Project	IEEE 802.16 Broadband Wireless Access Working Group < http://ieee802.org/16 >	
Title	Corrected pilot allocation for 4 BS transmit antennas	
Date Submitted	2004-11-12	
Source(s)	Qinghua Li, Xintian Eddie Lin, Shilpa Talwar Intel Corporation	qinghua.li@intel.com Voice: +1-408-765-9698
Re:		
Abstract	Pilot allocations for 4 transmit antennas in optional FUSC and Band AMC	
Purpose	Adoption of proposed changes into P802.16e Crossed-out indicates deleted text, <u>underlined blue indicates new text change to the Standard</u>	
Notice	This document has been prepared to assist IEEE 802.16. It is offered as a basis for discussion and is not binding on the contributing individual(s) or organization(s). The material in this document is subject to change in form and content after further study. The contributor(s) reserve(s) the right to add, amend or withdraw material contained herein.	
Release	The contributor grants a free, irrevocable license to the IEEE to incorporate material contained in this contribution, and any modifications thereof, in the creation of an IEEE Standards publication; to copyright in the IEEE's name any IEEE Standards publication even though it may include portions

Figure 251c—Pilot allocation for 4-antenna BS for the optional FUSC and the optional AMC zones

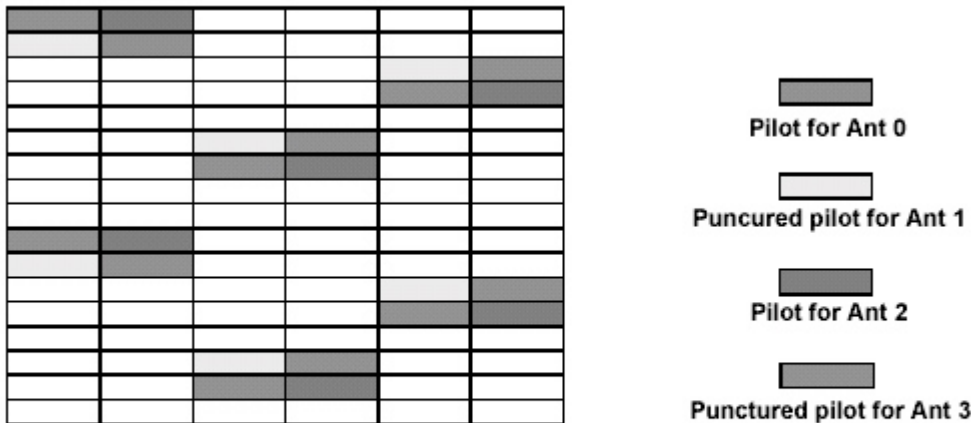
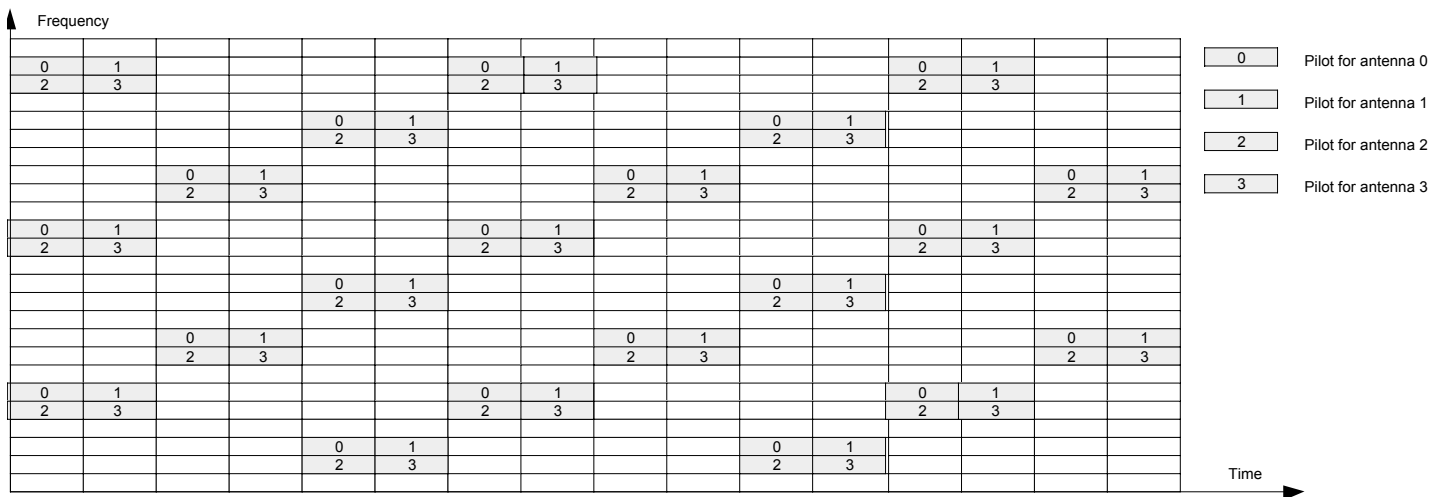
[Delete Fig 251c in section 8.4.8.3.2]

[Replace Fig 251c in section 8.4.8.3.2]

For 4-antenna base station (BS), pilot pattern is shown in Figure 1. The pilots has a periodicity of 9 in frequency axis, and a periodicity of 2 in time axis. The locations of the pilot tone is interleaved to maximize the uniformity of the distribution in freq-time plane. The periodic placement makes the interpolation and tracking easier. The pilot density of each antenna is 1/18.
